CONTRACT

Letting Date: February 17, 2015 Contract ID: 78-0293-102 Bid Order No.: 306
County: POTTAWATTAMIE Project Engineer: COUNCIL BLUFFS RCE
Cost Center: 601000 Object Code: 890 DBE Commitment \$2,365,826.80
Contract Work Type: GRADING

This agreement made and entered by and between the IOWA DEPARTMENT OF TRANSPORTATION,
CONTRACTING AUTHORITY, AND
AMES CONSTRUCTION, INC. OF BURNSVILLE, MN, (AM193), CONTRACTOR

Replace plan sheets C.5 & C.6 for IM-NHS-029-3(102)48--03-78 with the attached sheets:

SITE PLAN

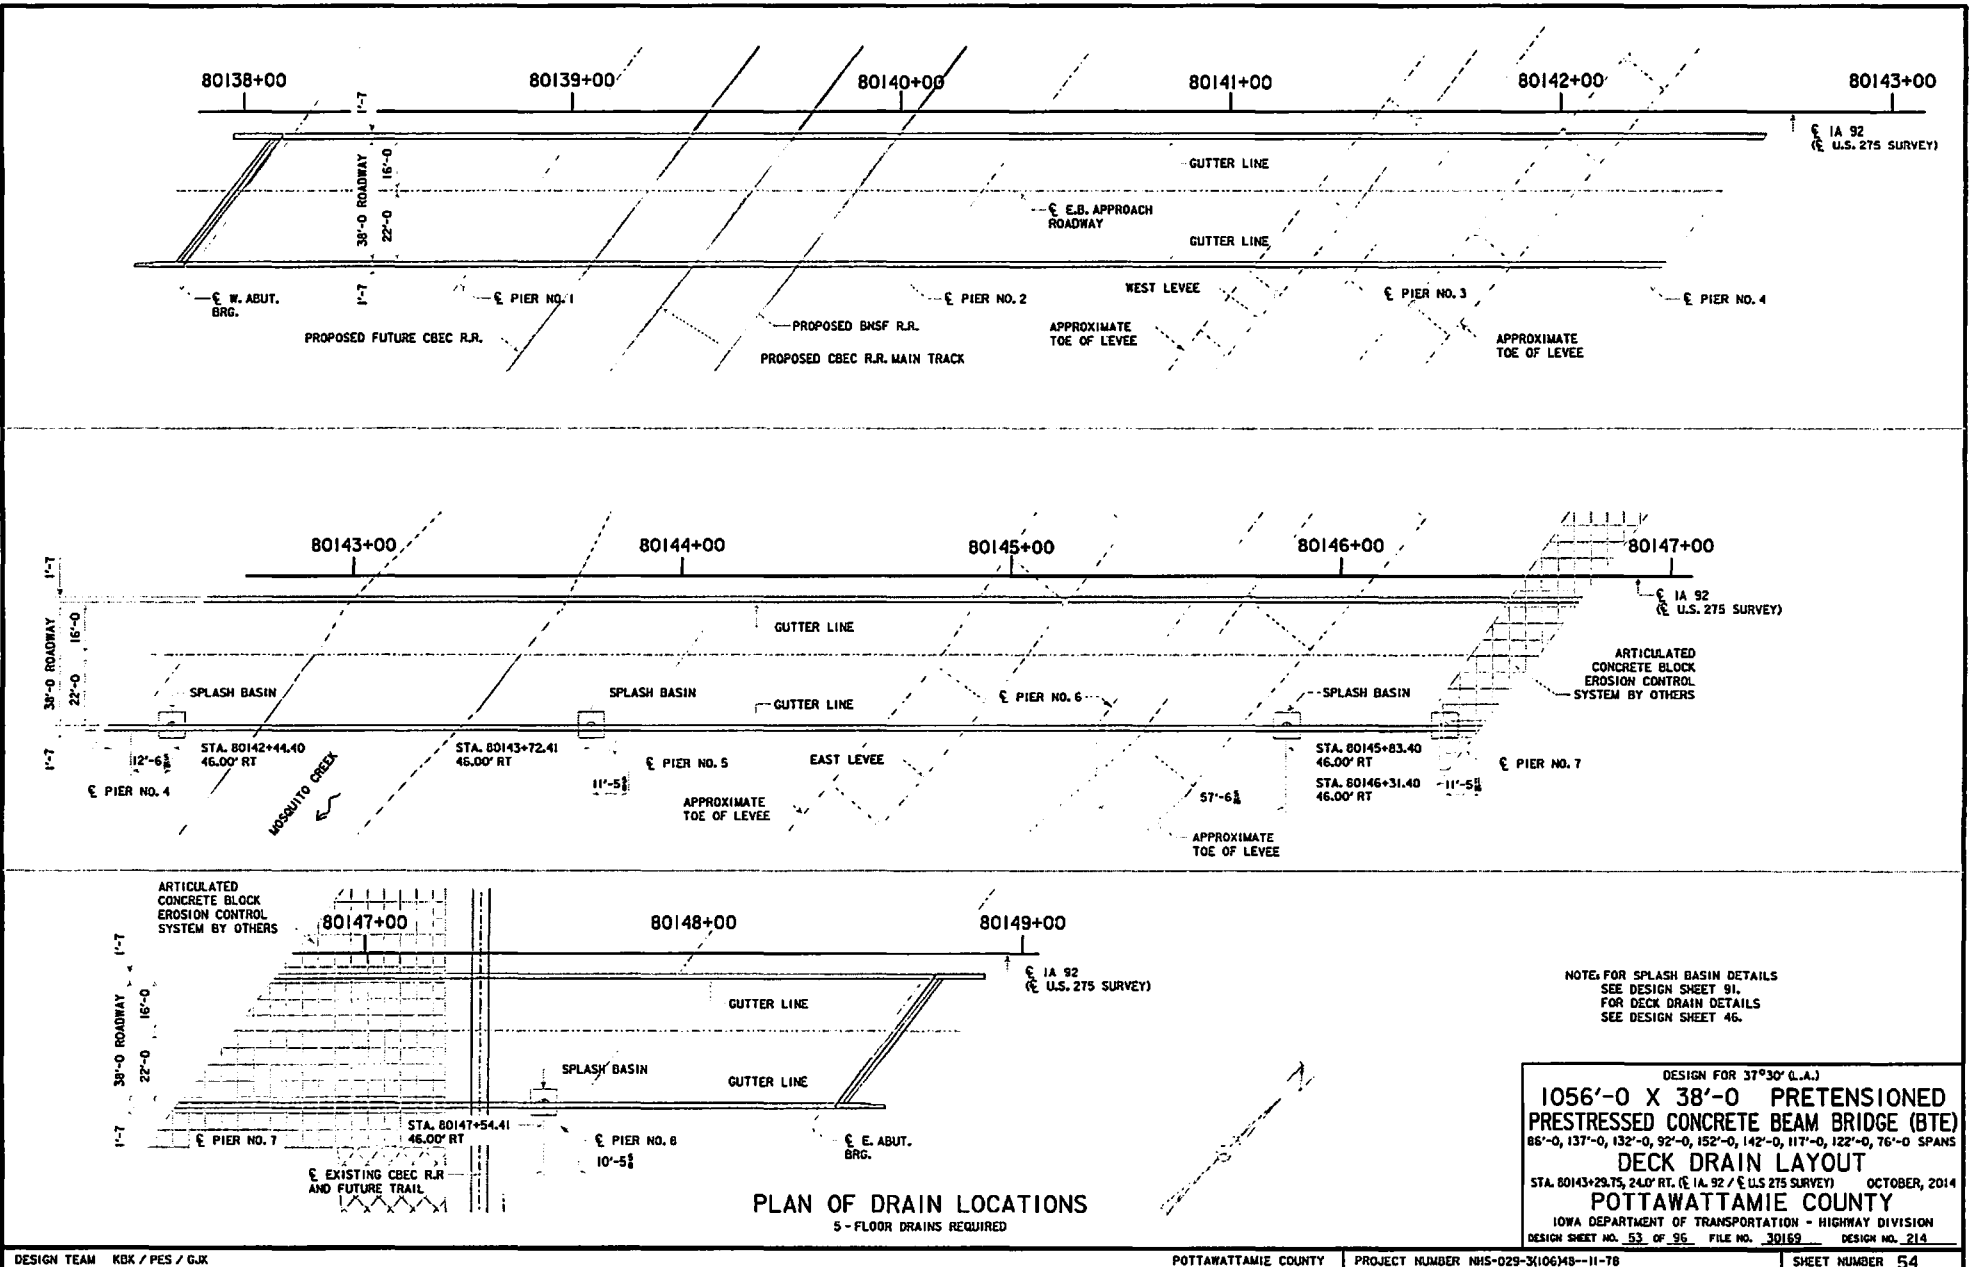
Replace Sheet 7 with attached Sheet 7.

Changes were made to show the piggyback extension adjacent to Pier 6 and the "Articulated Concrete Block Erosion Control System" adjacent to Pier 7.

WORKING PADS PLAN

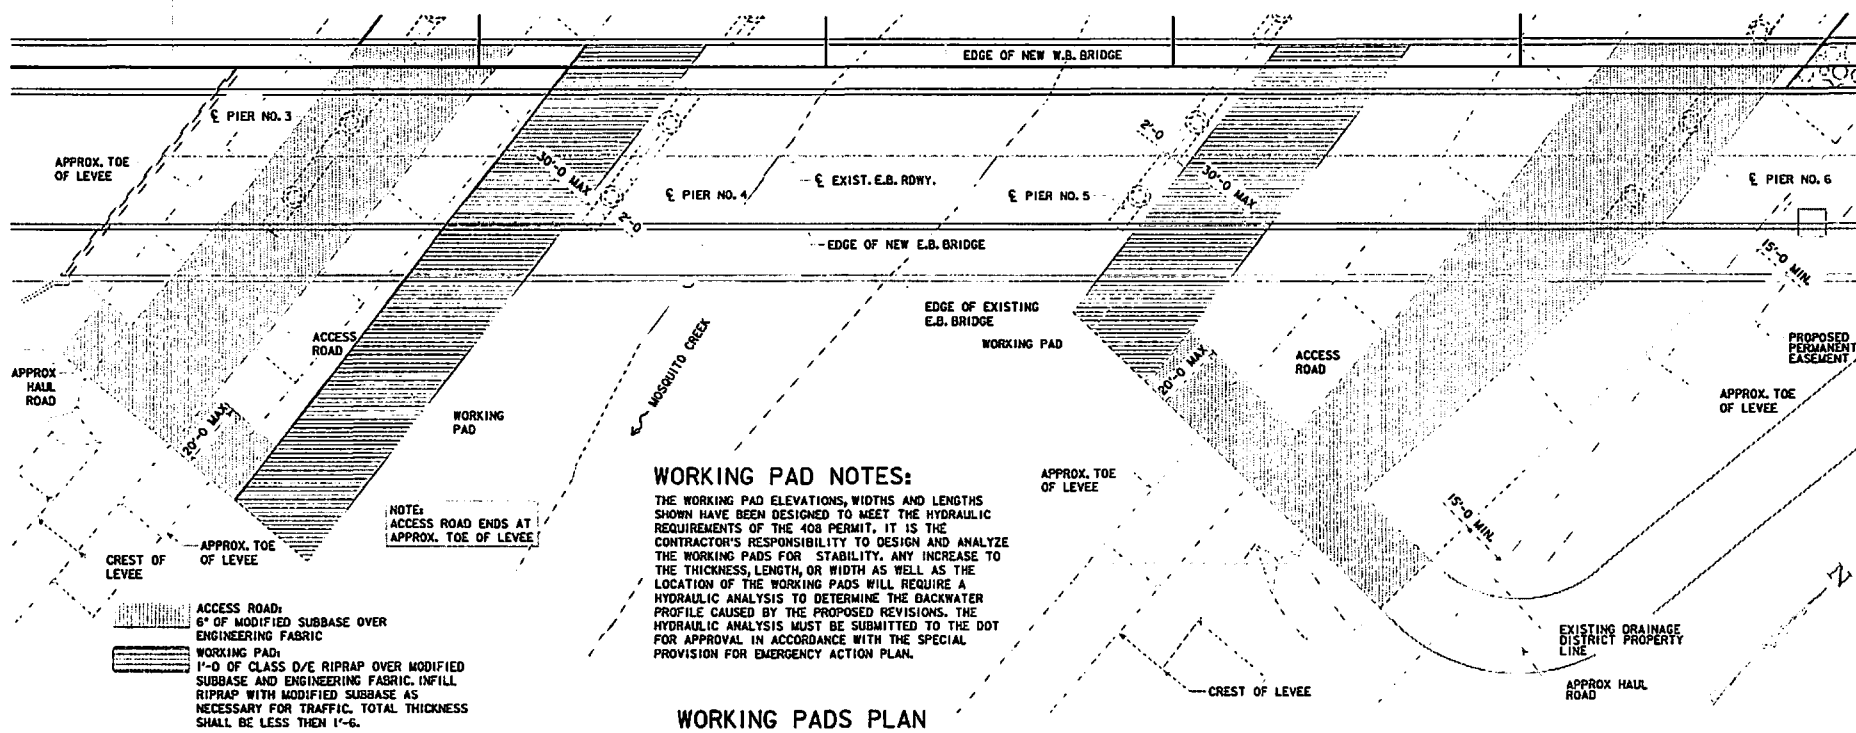
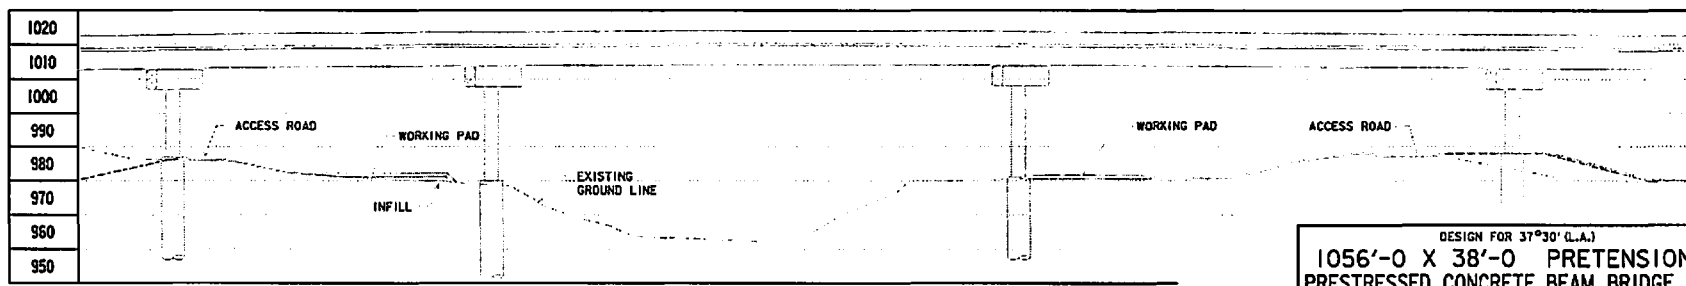
Replace Sheet 97 with attached Sheet 97.

Revised Working Pads to accommodate the piggyback extension. Revised Working Pad Notes.

THE WORKING PAD ELEVATIONS, WIDTHS AND LENGTHS SHOWN HAVE BEEN DESIGNED TO MEET THE HYDRAULIC REQUIREMENTS OF THE 408 PERMIT. IT IS THE CONTRACTOR'S RESPONSIBILITY TO DESIGN AND ANALYZE THE WORKING PADS FOR STABILITY. ANY INCREASE TO THE THICKNESS, LENGTH, OR WIDTH AS WELL AS THE LOCATION OF THE WORKING PADS WILL REQUIRE A HYDRAULIC ANALYSIS TO DETERMINE THE BACKWATER PROFILE CAUSED BY THE PROPOSED REVISIONS. THE HYDRAULIC ANALYSIS MUST BE SUBMITTED TO THE DOT FOR APPROVAL IN ACCORDANCE WITH THE SPECIAL PROVISION FOR EMERGENCY ACTION PLAN.

**RAMP D ALT II
BACK TO BACK
MSE WALL WITH
STONE BACKFILL
TYPICAL SECTION**

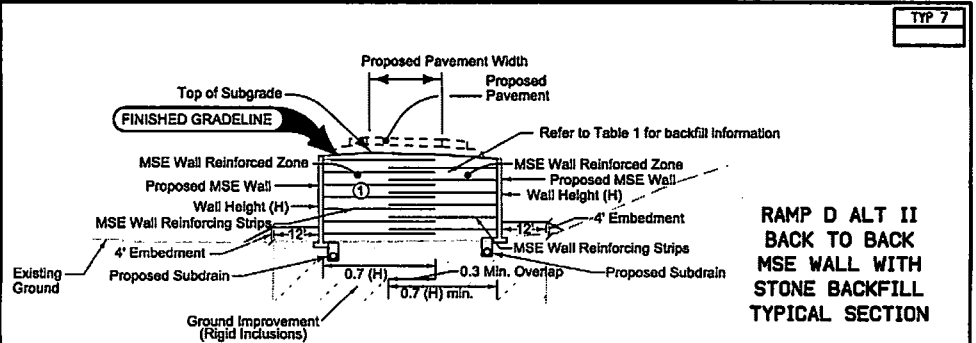
Replace Sheet Q.62 to correct TYP 6 Title and add Stationing for RAMP D ALT II and add notes to Typ 8 pertaining to Backfill information and ground improvements.

ABUTMENT ROCKER (RAI)

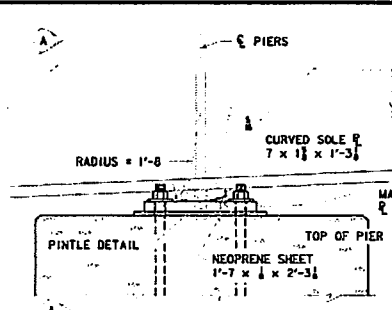
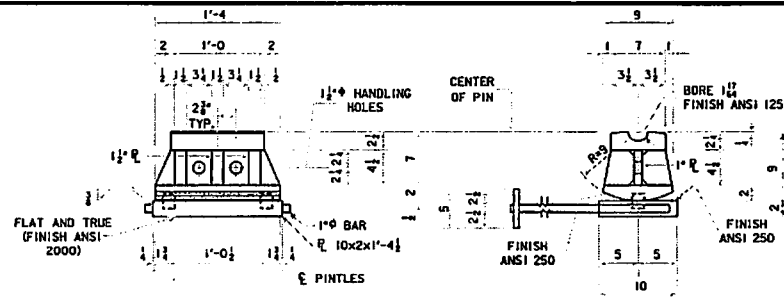
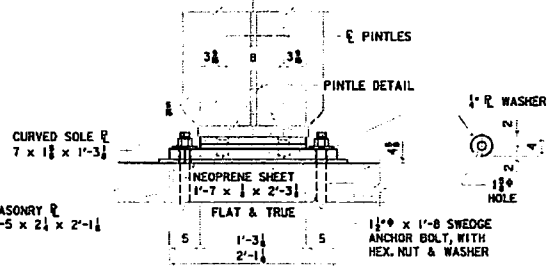
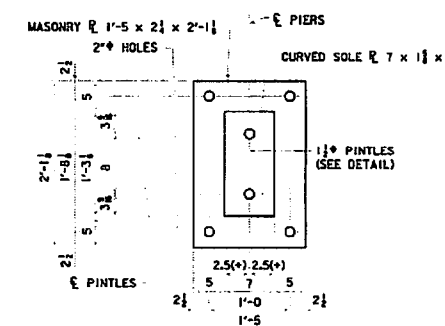
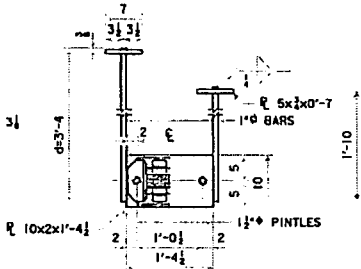
Add attached alternate sheet 38A.

This sheet provides a Rocker Weldment Alternate to the Cast Iron Rocker detailed on Sheet 38. The Contractor can use Rocker Weldment Alternate with no additional payment for the added Structural Steel weight.
